Service Bulletin

RRP Service Bulletin No: RRP SB379

Title: Cummins Engine Placard – Checking Engine Start RRP# 476530

Product Series: Advanced Tie Plate Inserter [ATPI]

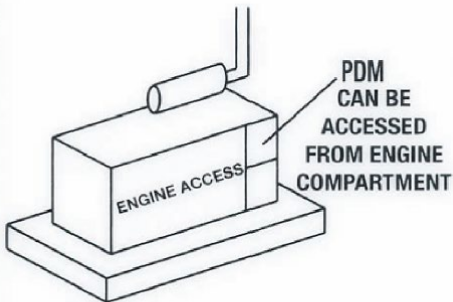
Summary: RRP# 476530 Cummins *Check Engine Start* placard is available to apply to the Cummins engine cover.

Action: Adhere the RRP# 476530 placard to the engine exterior along other engine informational placards.

Completion / Resolution: Continue with normal machine operation after adhering the RRP# 476530 engine placard.

LABEL PART NUMBER: A068H731

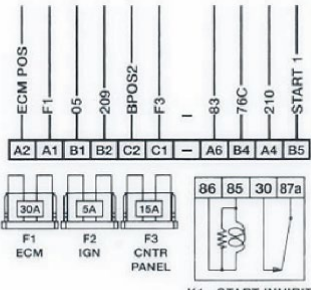
**IF ENGINE DOES NOT START
CHECK FOR BLOWN FUSE(S).**

**IF A BLOWN FUSE IS FOUND
REFER TO A CUMMINS®
AUTHORIZED REPAIR LOCATION OR
EQUIPMENT MANUFACTURER**

PDM
CAN BE
ACCESSED
FROM ENGINE
COMPARTMENT
